Attn: Juliet Walker, Planning Director
Re: 105 Bartlett St

To: TAC 5/5/20 Site Review Meeting
From: Nancy & Brian Johnson, 81 Clinton St, Portsmouth
Date Sent: May 3, 2020

Re: **Moxy Hotel**
XSS Hotel, LLC
53 Green Street

A Different Way to Meet the Goals

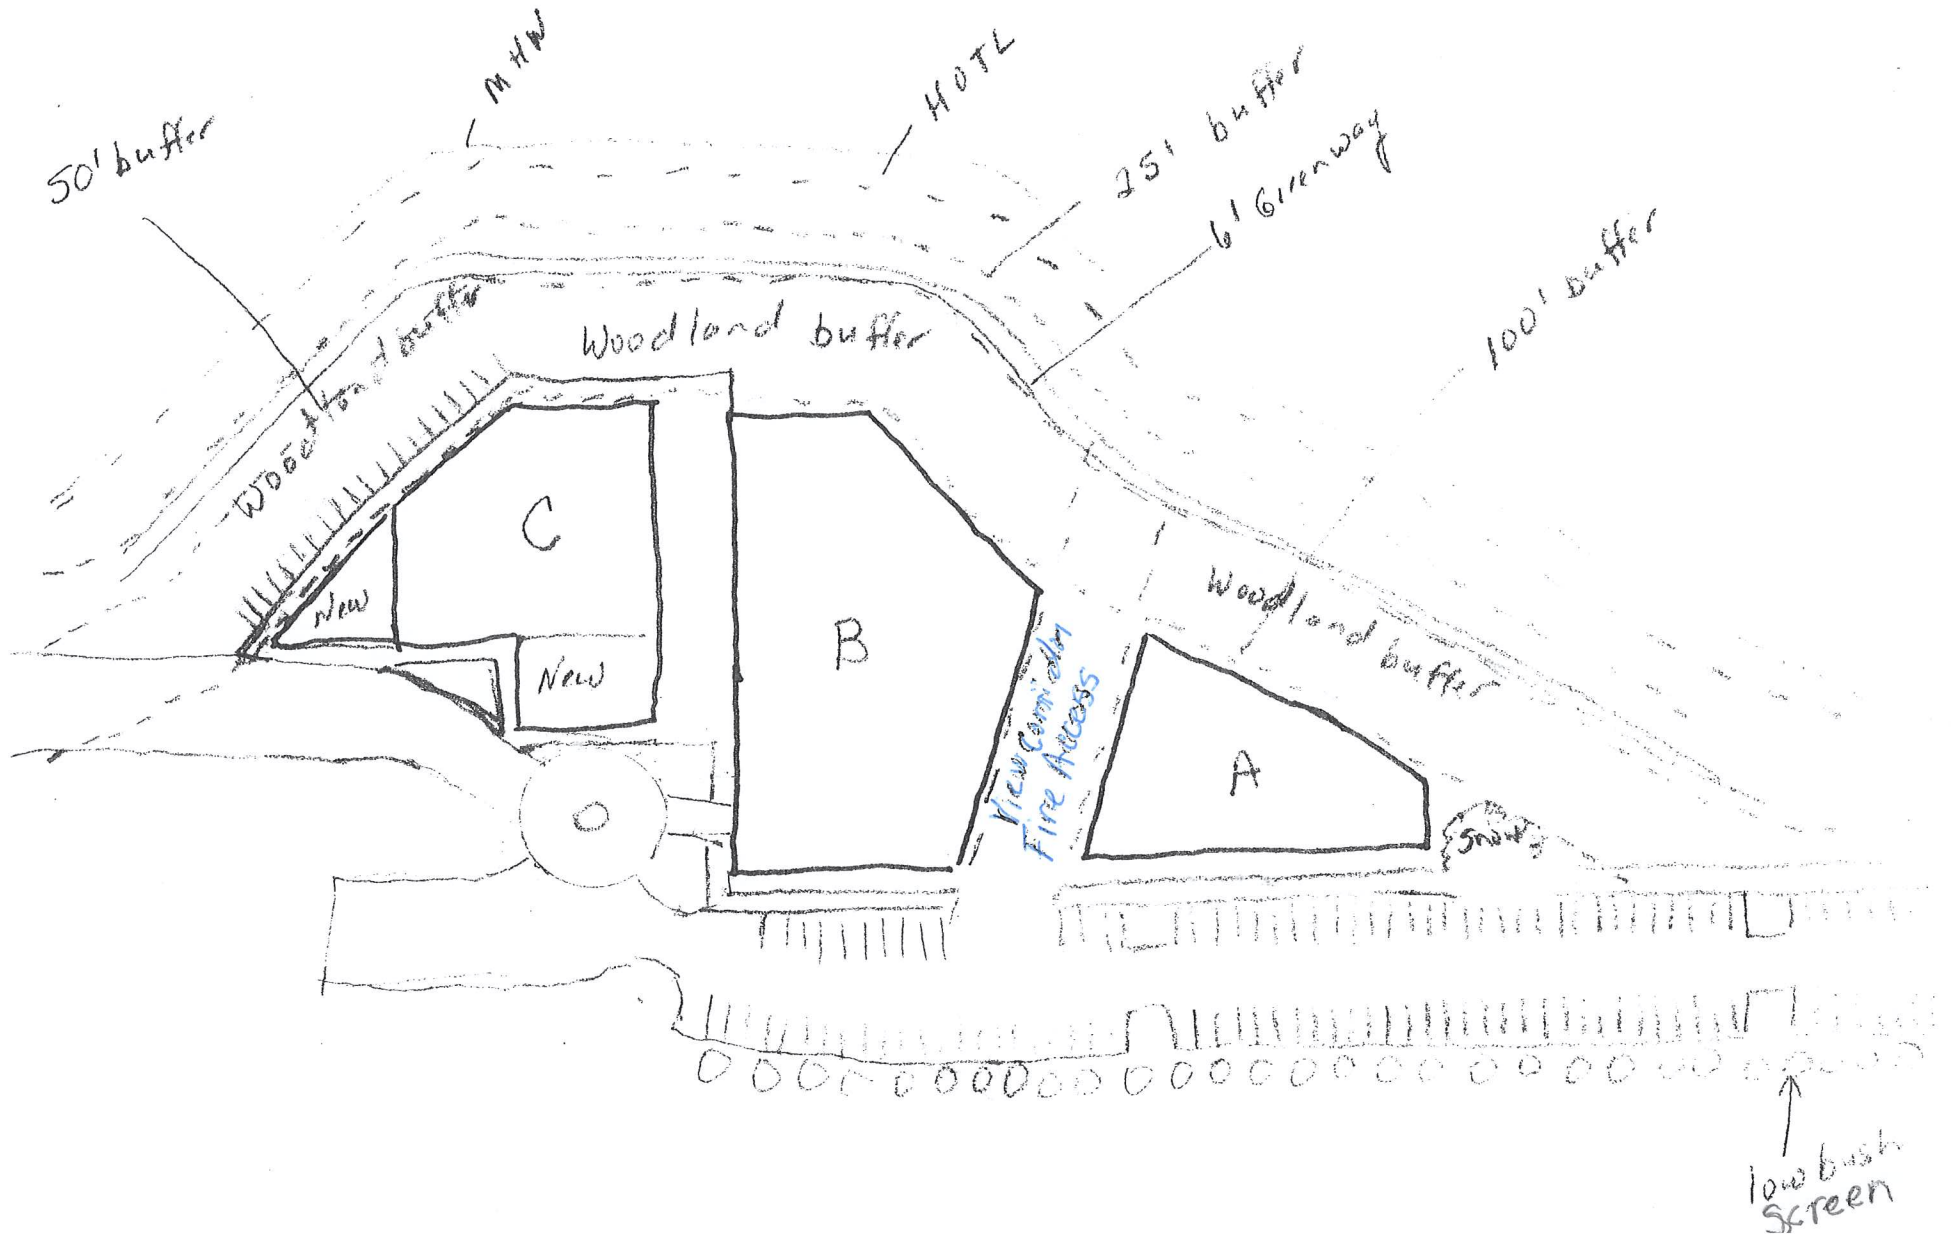
This is a possible site plan which could move the buildings out of the 100' Shoreland Buffer by moving them back by 50'. It would certainly preserve some of the Woodland Buffer and still allow much of the volume of units this developer is trying to achieve. This is NOT to scale. Site Plan C-102.2 from the March 19, 2020 Planning Board meeting submission by Tighe and Bond was traced to create this plan. It should be noted a fire access to the rear of buildings B and A is created using the View Corridor. The parking requirement could likely be met with this design. It would open up better view areas to the North Mill Pond on both buildings B and C. The snow removal area is where the originally proposed Salem St View Corridor was, keeping the snow and its contaminants out of the North Mill Pond. Moving the circle back to its original position allows for more organized movement of trucks and cars. The new shapes would visually add a little character to the design.

Neighborhood Connector Road

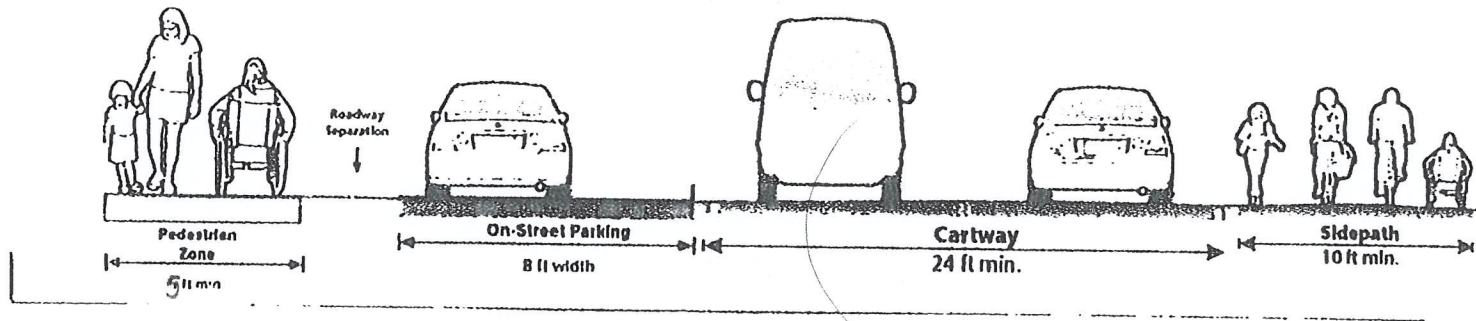
Using a Neighborhood Connector Road would allow for safe movement of cars, trucks, bicycles and pedestrians on this highly traveled roadway. The 5' Pedestrian and 3' roadway separation would have to line up against the first building, after vehicles have moved past the 50' safety area at the intersection of Bartlett and this new road. The 8' wide off-street parking could easily accommodate a large amount of cars along the Windows and Doors business. The 24' Cartway would create a better flow between cars and trucks and the 10' wide curbed sidpath along the North Mill Pond will allow for bicycle and pedestrian travel in either direction for safer exiting and entering of this property. **Starting from the entrance at Bartlett St to about Lot 157-1** as a Neighborhood Connector Road would free up sections of the wetlands buffer zone to have large amounts of pavement removed and be environmentally restored.

There should be **NO parking allowed** in the proposed cul-de-sac, especially not on the outer edge next to Ricci's Lumber Yard. The cul-de-sac just seems oddly placed with regards to flow of traffic. **Most people will take the path of least resistance and drive straight.** Parallel parking on a circle seems like something most people avoid. Its location seems more confusing then helpful in regards to traffic flow, access to the building and generally speaking. I would suggest moving it back to where it started *or remove it completely* and allow head in parking at the entrance of building C for ease of use for future residents. This parking area should be kept small and specific to avoid future parking issues. Doing this would free up some more unnecessary impervious surfaces.

C-102.1

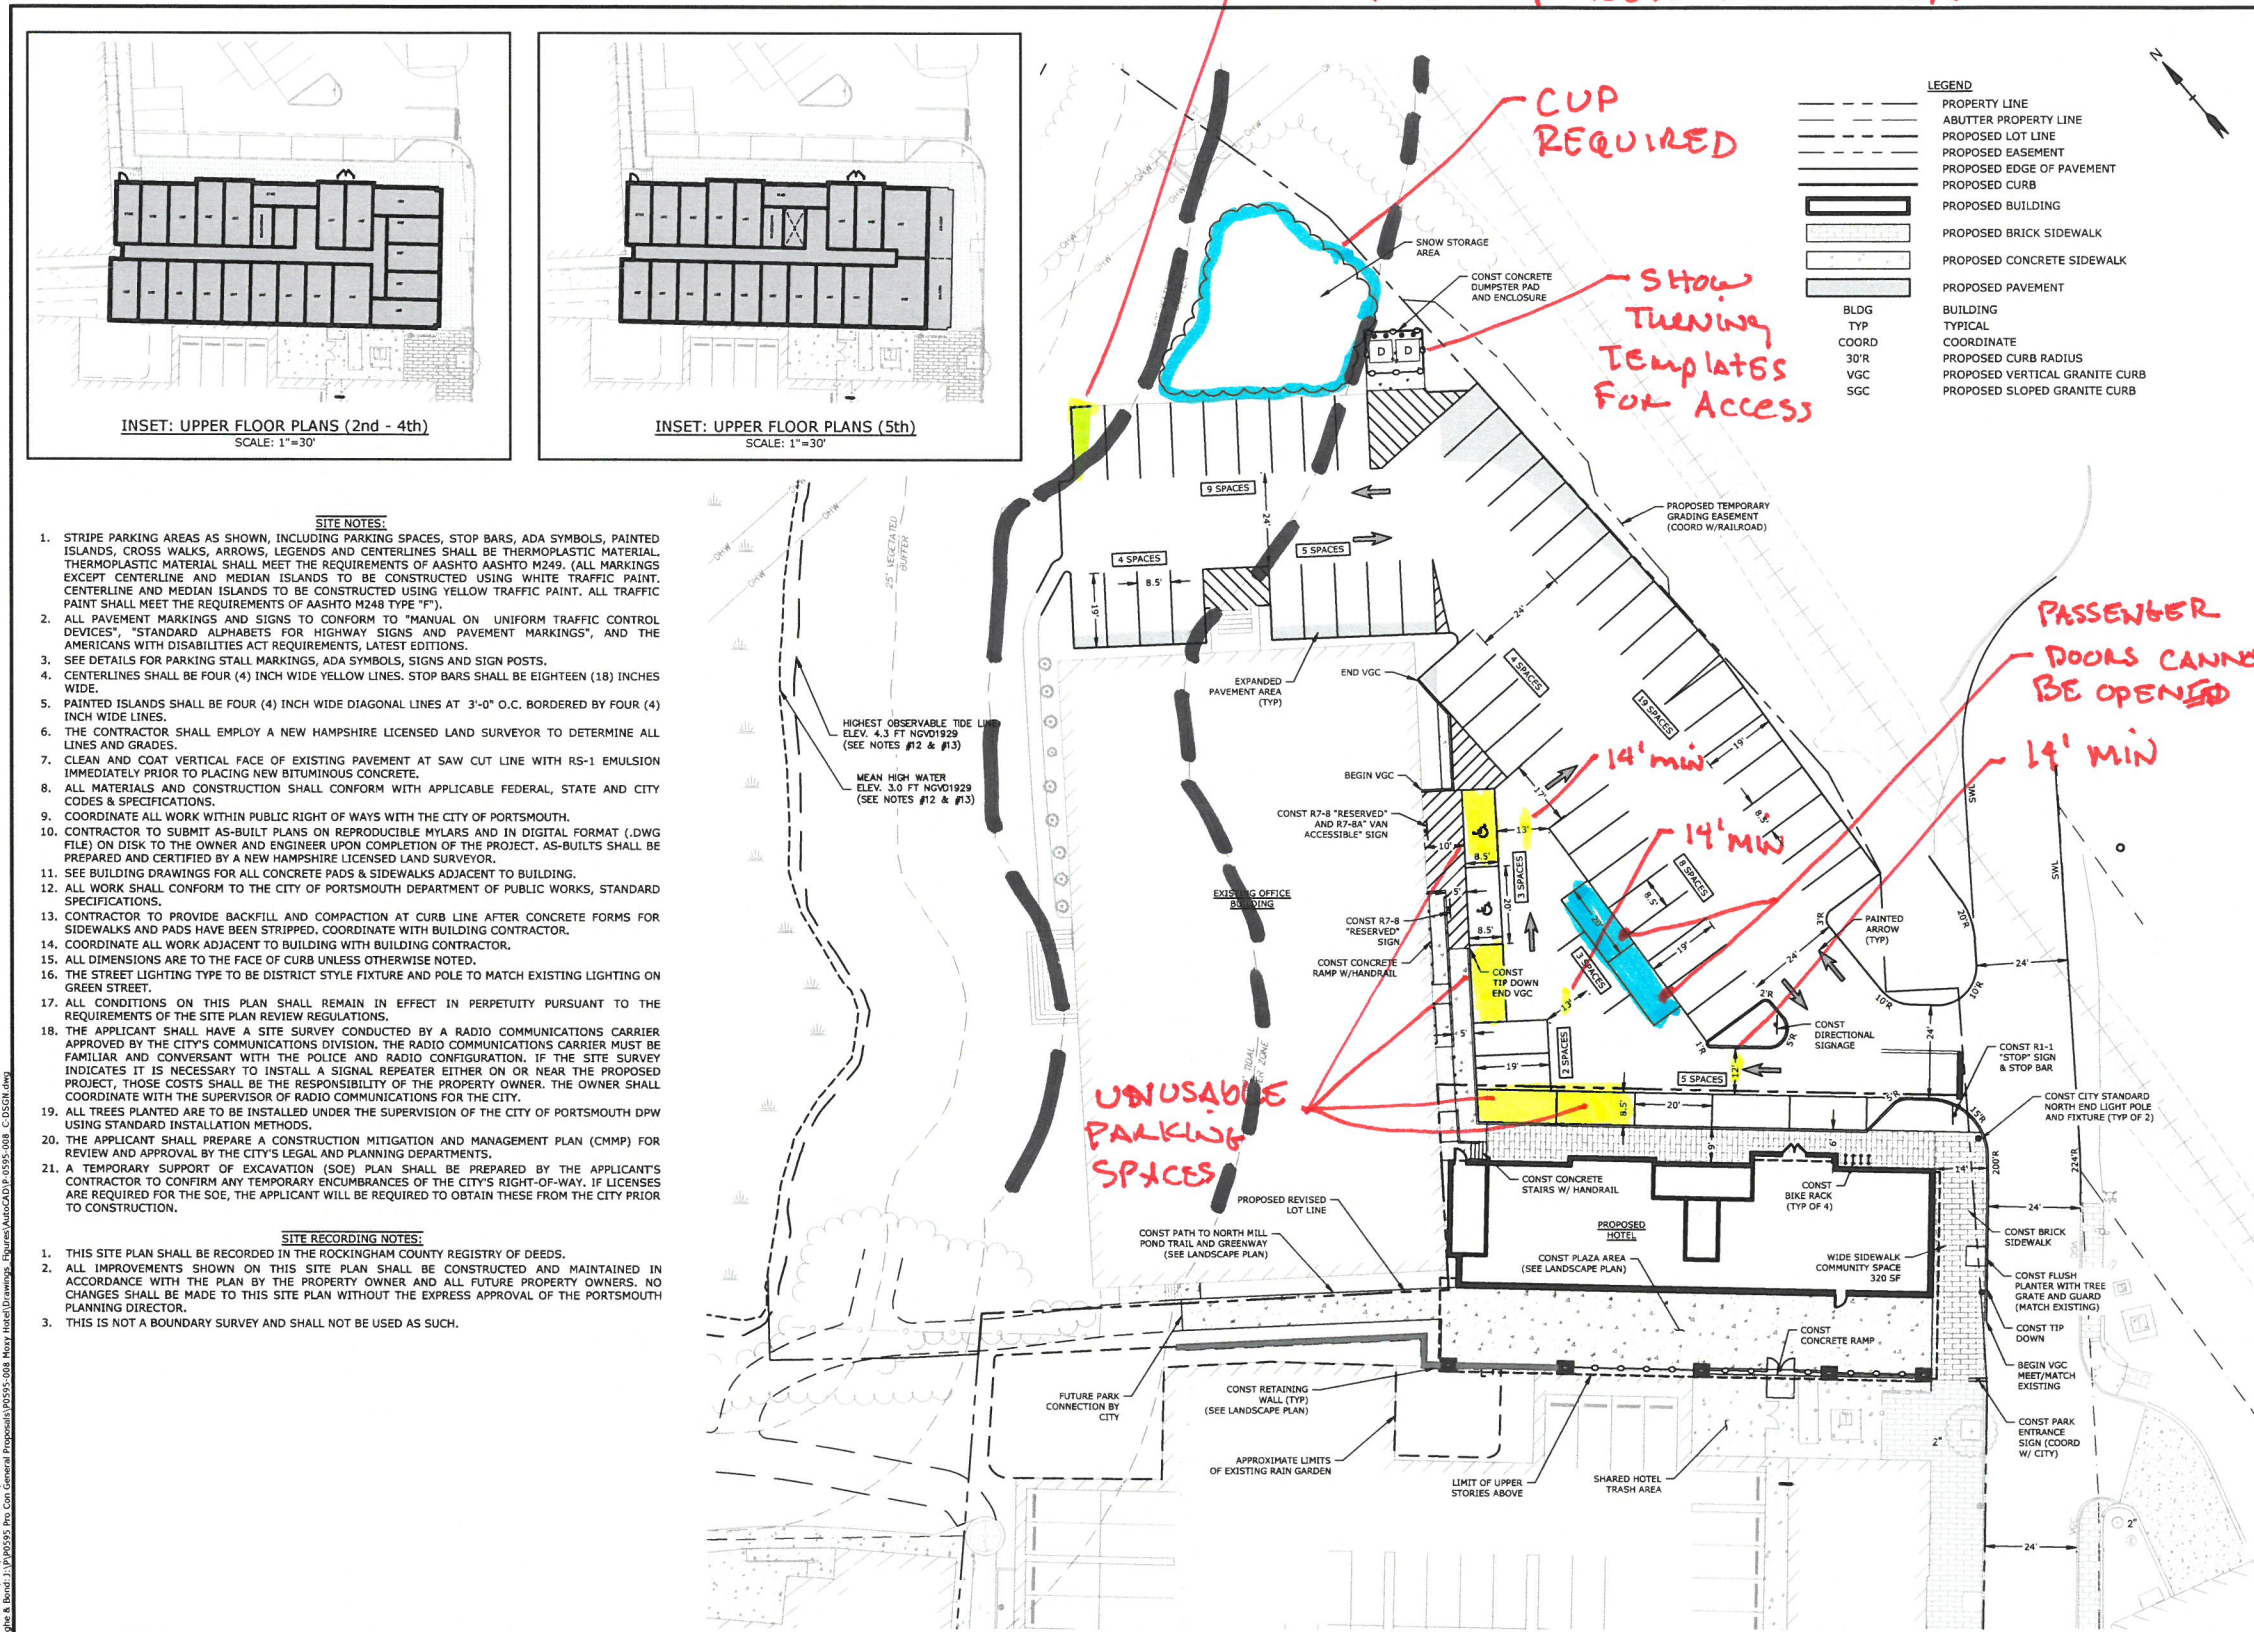
The proposed parking aisle width for one-way travel varies between twelve and 13-feet. The minimum width allowed by Zoning is 14-feet.

The Site Plan depicts several parking stalls that are completely non-functional. There is no way for a vehicle to access these parking stalls if any of the adjacent stalls are in use. Thus, it is our opinion that the site needs to be redesigned to provide compliant functional parking spaces. Attached is a photocopy of the site plan depicting the unusable spaces. The Designer indicates in their Shared Parking Calculation that 180 parking spaces are required during weekend evenings. They indicate that there are 180 spaces provided. As identified above, several of these spaces are not functional and thus they do not meet the parking requirements.
